United States Patent and Trademark Office

Application No.	Applicant(s)					
		10/617,791	HARA ET AL.					
	Office Action Summary	Examiner	Art Unit					
		Jeremy R. Severson	3653					
Period fo	The MAILING DATE of this communication app or Reply	ears on the cover sheet with the c	orrespondence address					
WHIC - Exter after - If NO - Failu Any (ORTENED STATUTORY PERIOD FOR REPLY CHEVER IS LONGER, FROM THE MAILING DANSIONS of time may be available under the provisions of 37 CFR 1.13 SIX (6) MONTHS from the mailing date of this communication. Period for reply is specified above, the maximum statutory period were to reply within the set or extended period for reply will, by statute, reply received by the Office later than three months after the mailing and patent term adjustment. See 37 CFR 1.704(b).	ATE OF THIS COMMUNICATION 36(a). In no event, however, may a reply be time vill apply and will expire SIX (6) MONTHS from cause the application to become ABANDONE	N. nely filed the mailing date of this communication. D (35 U.S.C. § 133).

DETAILED ACTION

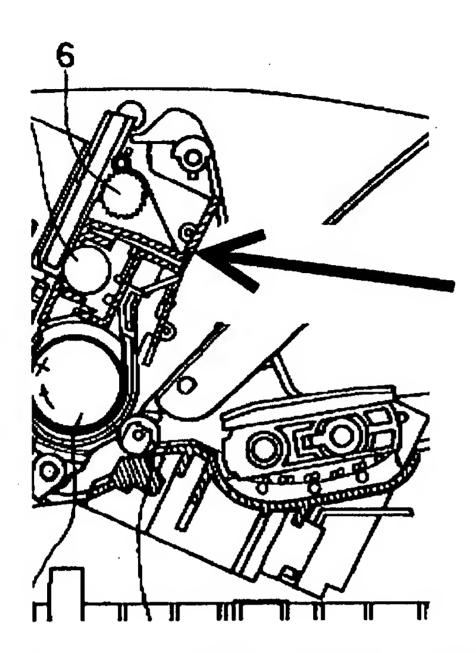
Re claims 3 and 6, Nishiberi discloses everything claimed, including a restricting member arranged at said medium support or rear guide and restricting said record medium put in said depository such that said record medium is not spaced from said medium support or rear guide more than a predetermined distance and is transported along said medium support or rear guide when said record medium is fed into said image recording apparatus. Arrow in fig. below points to restricting member.
